# SLIDEOUT GEAR PACK UPDATE

### SLIDEOUTS

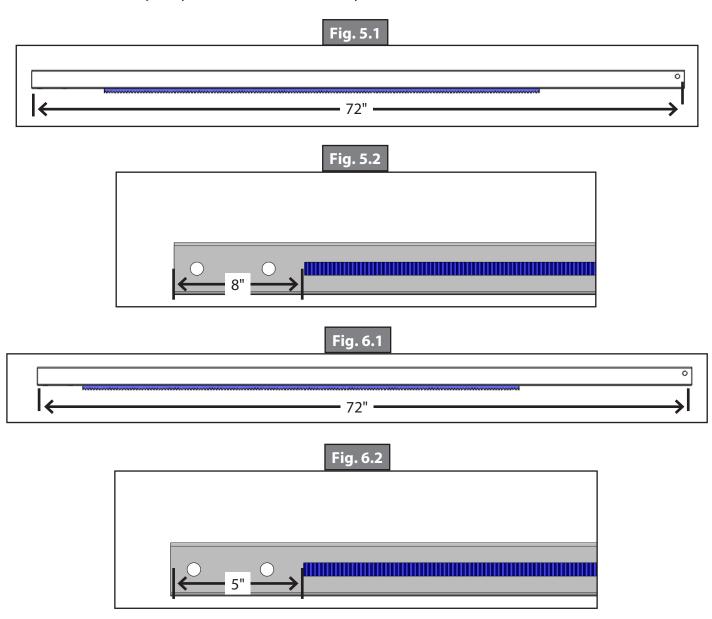
For customers with broken teeth in a gear rack, replacement parts will be two new inner arms, and two new gear packs. Both inner arms and gear packs must be replaced at the same time in order to maintain timing. The pressure angle of the spur gear on the new gear pack will not mesh with the pressure angle of the old gear rack.

- 2" x 2" Inboard (@20PA) **163778** (Fig. 5.1, Fig 5.2)
- 2" x 2" Outboard (@20PA) **145736** (Fig. 6.1, Fig 6.2)
- 2" x 2" Gear Pack Assembly (@20PA) 281331
- 2.5" x 2.5" Inboard (20PA) **143710** (Fig. 7.1, Fig 7.2)
- 2.5" x 2.5" Outboard (@20PA) **143707** (Fig. 8.1, Fig 8.2)
- 2.5" x 2.5" Gear Pack Assembly (@20PA) **324869**
- 2.5" x 2.5" Heavy Duty Steel Gear Pack Assembly (@20PA) 123356
